# **2004 - 2009 Cadillac XLR: Service Bulletin: #05-08-57-005B: General Waterleak Guide - (Oct 2, 2008)**

**Subject:** General Waterleak  
Guide

**Models:** 2004 - 2009 Cadillac  
XLR

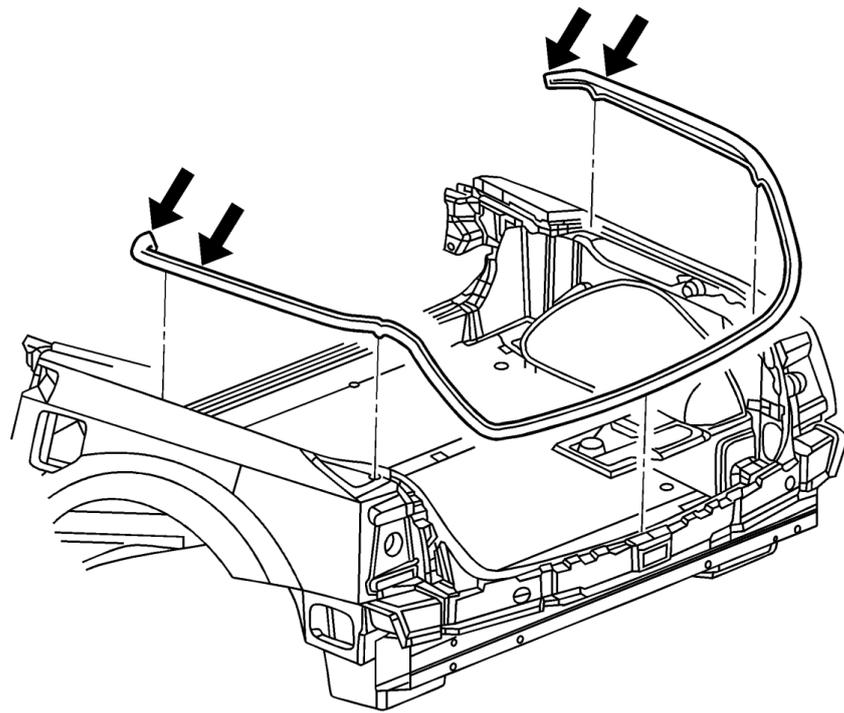
Water entry over the wheelhouse traced back to the joint between the rear compartment weatherstrip and quarter belt weatherstrip.

Separate the joints and lift each end 50-76 mm (2-3 in) enough to apply 3M™ Bedding and Glazing Compound, P/N 08509, inside the U-Channel of the weatherstrip. Refer to the illustration above. Apply enough compound so that it extends to both ends of the weatherstrip and will cause slight squeeze out when reinstalled. As you reinstall the weatherstrips, be sure the smaller weatherstrip is fully inserted into the opposite weatherstrip. Work the weatherstrips onto the flange and towards each other to ensure a tight joint when finished.

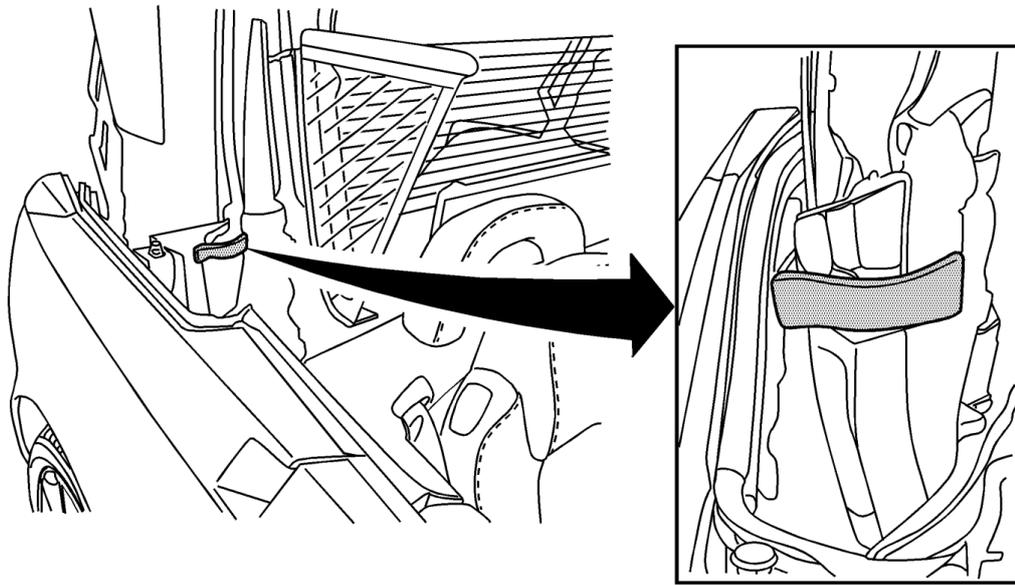
Water entry over wheel house and traced back to quarter belt cup. The cup drain is not large enough to allow water to drain adequately and floods over the dry side of the sealing system, which allows water to enter the trunk.

The cup joint is located at the rear of the quarter belt seal and it looks like a trough. This area is where the rear roof panel lower weatherstrip contacts when the roof is closed. The area just forward (toward front of car) of this cup is a “wet area” and to better manage the water into this wet area, a strip of foam must be added into the rear roof panel lower weatherstrip where it contacts the cup. Cut a strip of adhesive backed foam Kent Adhesive – Back Shim Stock, P/N P46475, 60 mm X 15 mm (2 1/4 in X 5/8 in). Clean the area of the rear roof panel lower weatherstrip where the foam will be added using de-natured alcohol before installing the foam strip to ensure adhesion. Refer to the illustration above.

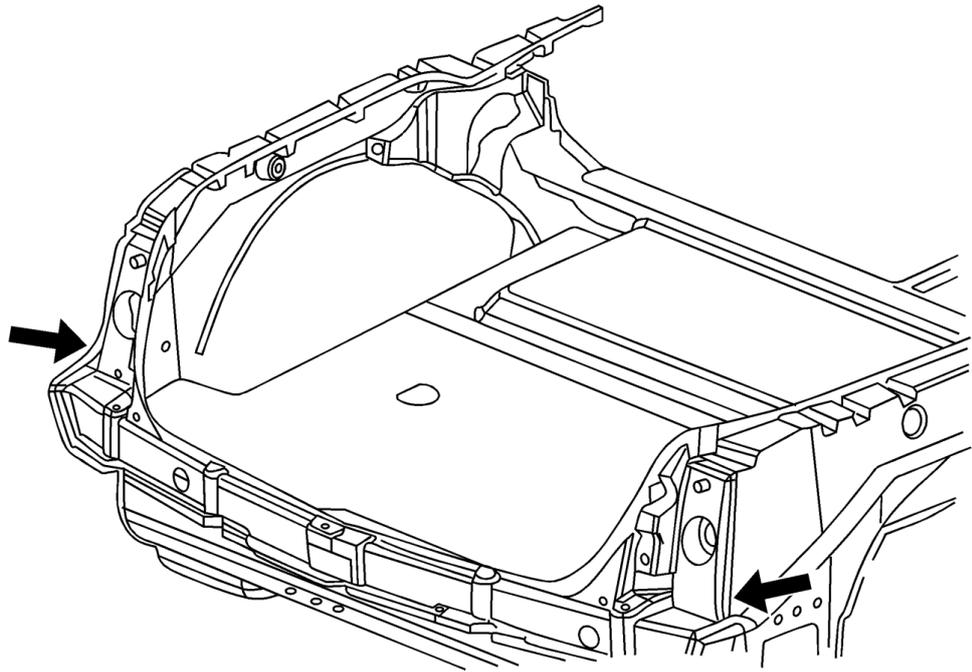
Water entry into rear tubs located behind the rear wheelhouses traced

to the area behind the rear tail lamps.

There are a number of panels that are bonded together in this area. If water entry is traced to this area, remove the rear tail lamp on the affected side to help gain access. Use Kent Seam Sealer, P/N P10200, to seal the affected joint. Refer to the illustration above.

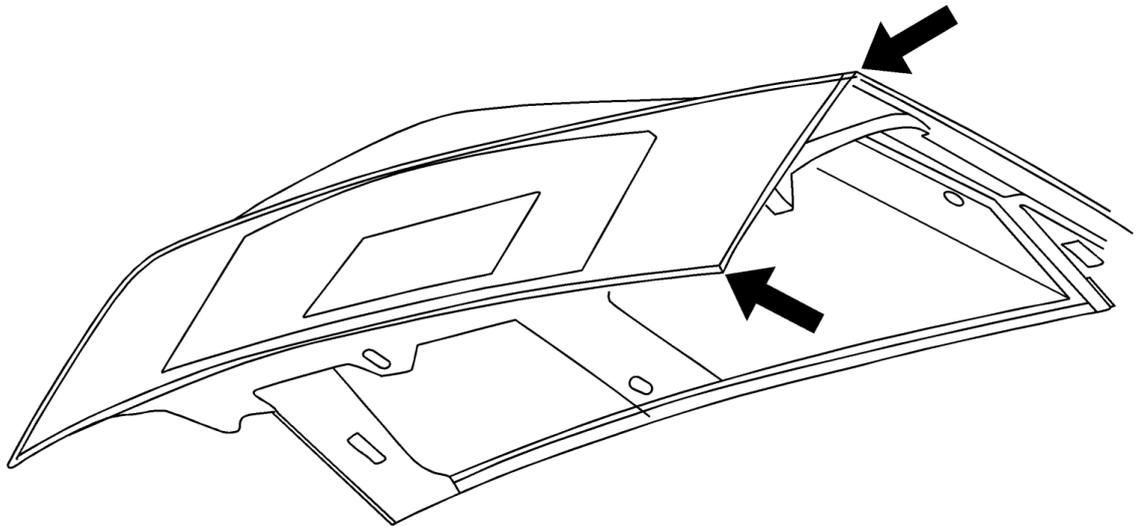
Water entry into the rear compartment. Water may be present on the sill of the lower rear compartment opening (near the latch). Water may be seen dripping from the rear compartment lid inner trim at the lower corners.

Seal the area of the rear compartment lid inner and outer panels at the outer most vertical seam (between arrows – either side). The seam is on the inside of the rear compartment lid. Refer to the illustration above. Use Kent Seam Sealer, P/N P10200, to seal the seam for best appearance.
